Product Change Notification

Document No. PCN-A-20260506 **Revision** 1.0

PCN TOPIC: M900EK specification upgrade and assembly optimization.

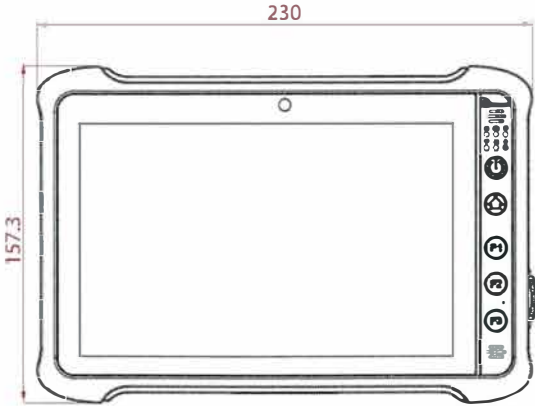
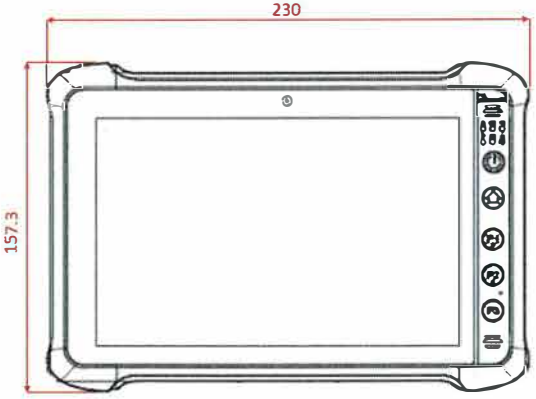
1. M900EK will support USB Type-C PD charging through the USB-C port.
 2. To enhance M900EK assembly, the panel installation orientation will be reversed for optimization.
- Both changes will optimize the same product functionality and have no impact on product quality or intended use.

Item	Original	New
I/O Port	1 x USB 3.0 (Type A) 1 x USB 3.0 (Type C) 1 x 15pin D-sub connector 1 x DC jack	1 x USB 3.0 (Type A) 1 x USB 3.0 (Type C, support PD 3.0 Charging) 1 x 15pin D-sub connector Remove DC jack
Appearance		Screen position shift
